**THE ABLE MARINE ENERGY PARK DEVELOPMENT CONSENT ORDER 2012  
(PINS REFERENCE NUMBER: TR030001)**

**SUMMARY WRITTEN REPRESENTATIONS OF E.ON UK PLC  
(UNIQUE REFERENCE NUMBER: 10015527)**

**Eon AMEP Easement Corridor – AME-08093**

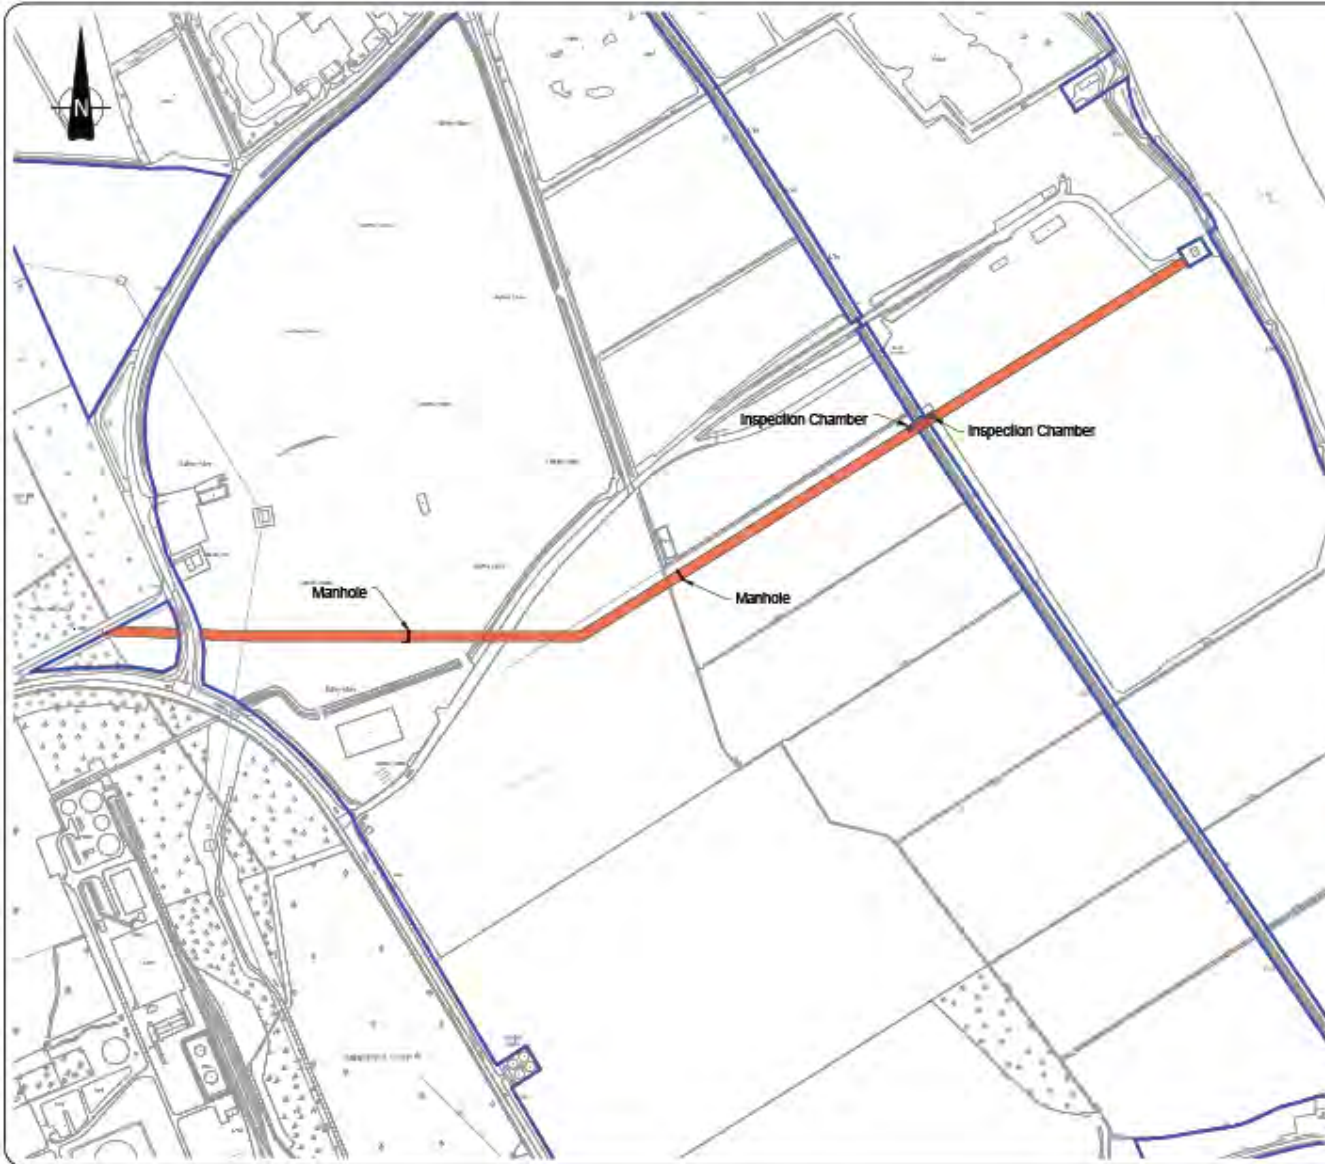
- 4.8 On 17<sup>th</sup> May 2012, the undertaker provided two plans in an e-mail to E.ON : AME-03033 B 'E.ON pipeline typical section' and AME 08093 C 'E.ON AMEP Easement corridor'. This e-mail and drawings proposed a 12.5m easement corridor, again without any explanation as to how workable this might be for E.ON in practice. These drawings are included within **Appendix 5**.

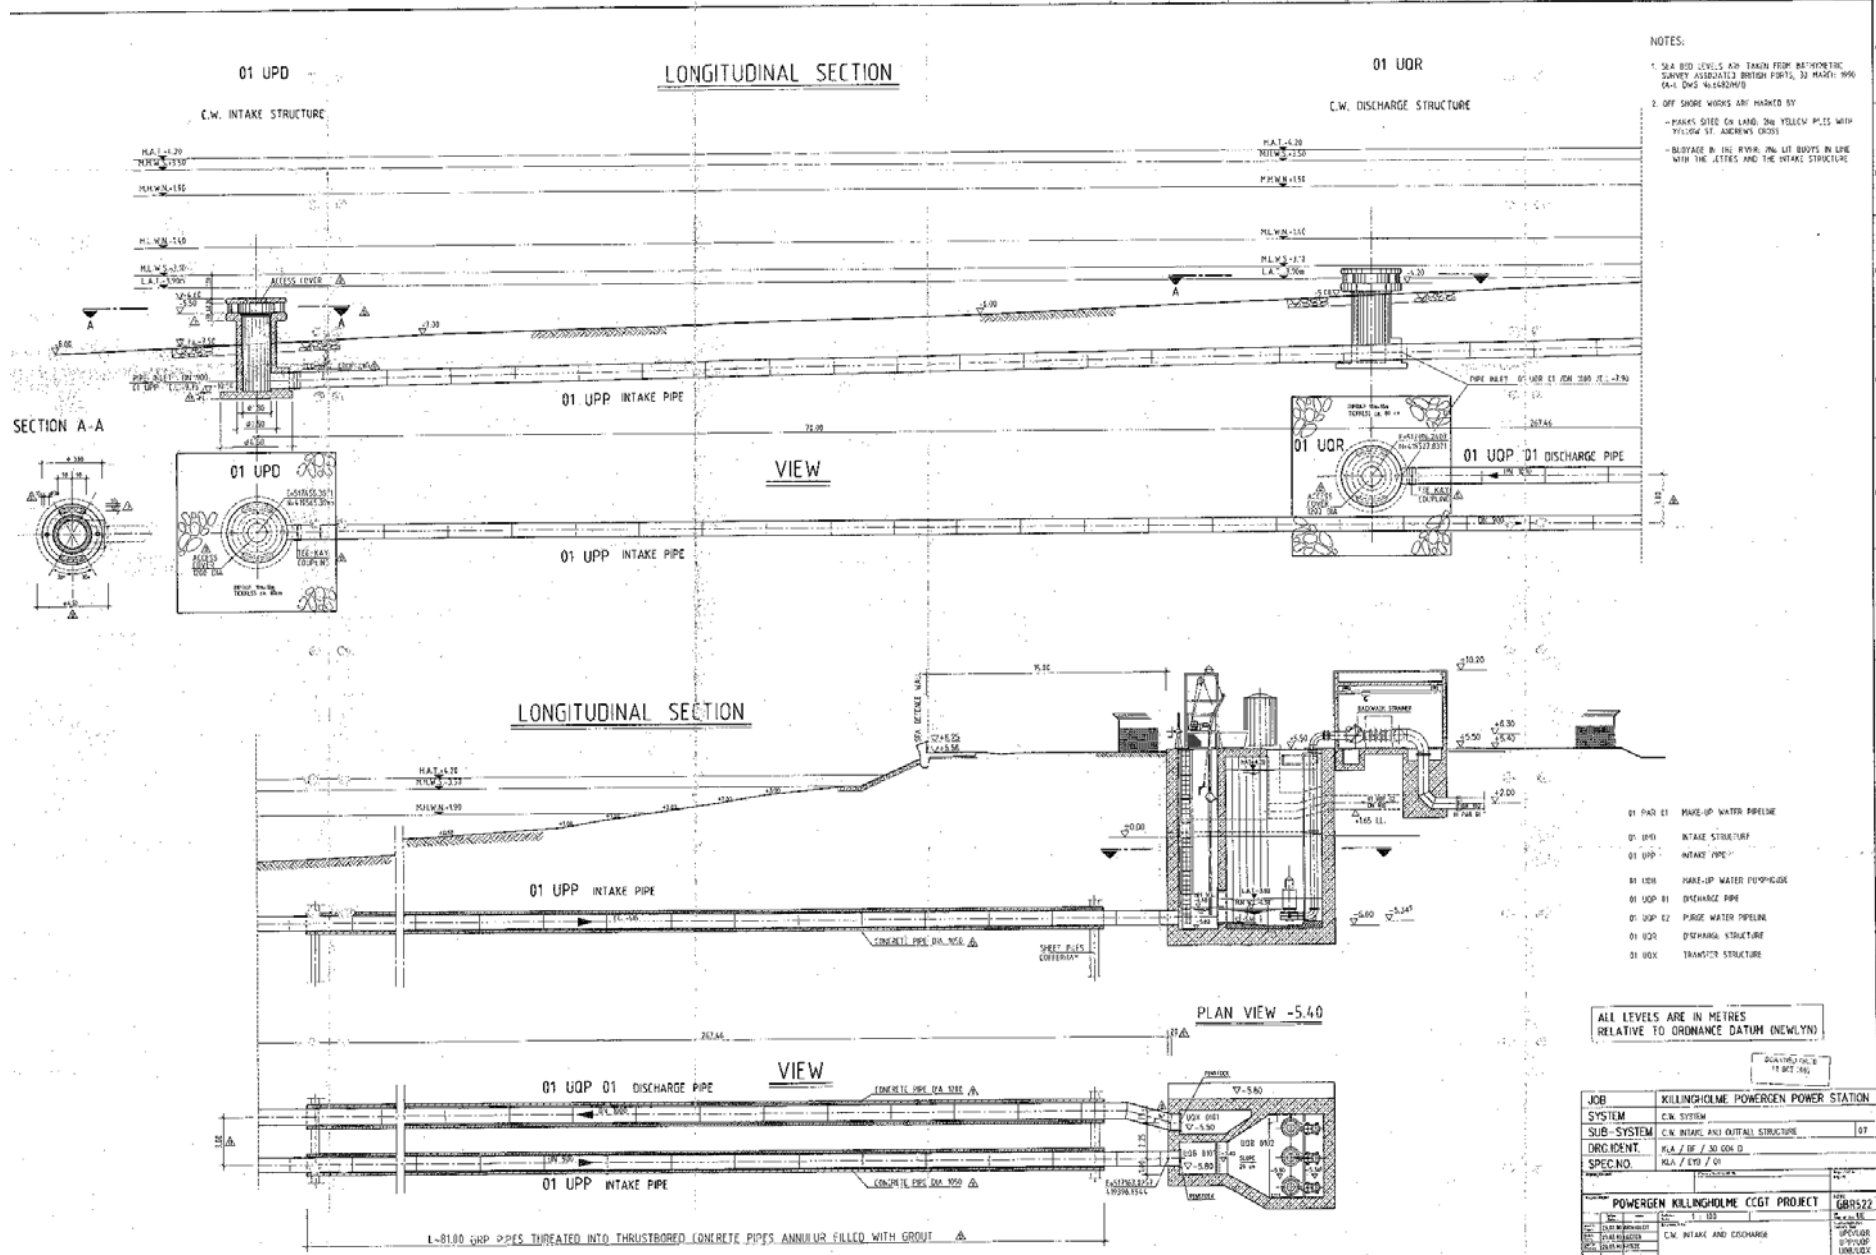
- After 30 weeks of simulation, approximately 0.9m of bed erosion in the vicinity of the E.ON intake and continuing (Figure 11 of Technical Note DHR4808-01, March 2012)
- After 30 weeks of simulation, approximately a 2.3m rise in bed level at the E.ON outfall and continuing (Figure 11 of Technical Note DHR4808-01, March 2012)
- Inshore of the E.ON outfall up to 3.8m of deposition is predicted (Figure 10b of Technical Note DHR4808-01, March 2012).

Of more concern is that there is a real possibility the outfall structure will become covered in sediment and possibly become blocked during periods of CW system inactivity. From Drawing GBR 522-T217-00-1001, the bed level at the outfall is -5.0 mODN. Mean Low Water Spring is -3.1 mODN, which covers the top of the outfall structure. The difference between -5.0 and -3.1 is 2.1 m. Therefore accretion of 2.3 m would more than cover the top of the outfall structure.

Furthermore, the change in bed level will result in potentially more suspended sediment on occasions e.g. the accreted material at the outfall and inshore of the outfall could become resuspended via wave action and the material eroded from the intake could be drawn into the CW system.
